# National Association of Lift Makers

## **Oakland Elevators Ltd, Ceiling Tray Locks**

Title :  
Ceiling tray locks

TI no: 002  
Issued by: D Holmes  
Approved by: PM Chamberlain

Sketch 2 shows the comparative sizes of the old and new brackets.

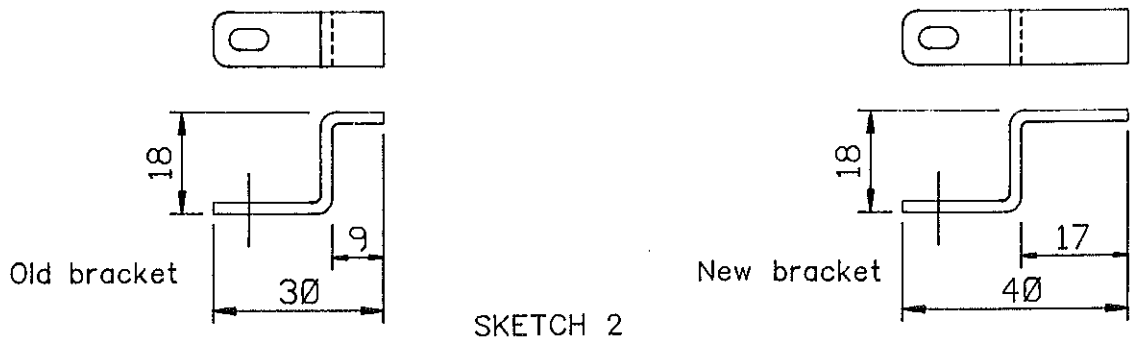
We have recently had an incident reported which was caused by a ceiling tray lock not being in the fully closed position.

The ceiling tray lock in question is incorporated into Oakland passenger lifts commissioned between September 1991 and September 1993.- subsequent installations incorporate modified brackets (see below). The assembly details are as shown in sketch 1.

The lock details show 2 dots which when aligned indicate that the lock is in the 'locked position'. Please carefully examine that the dots are aligned when locking the ceiling tray.

As a precautionary measure, longer clamping brackets are now available and we would advise that these should be fitted. Please contact Peter Masterson at Oakland stores with any requirements you may have.

Please examine any Oakland passenger lift that you may service which was commissioned between September 1991 and September 1993.
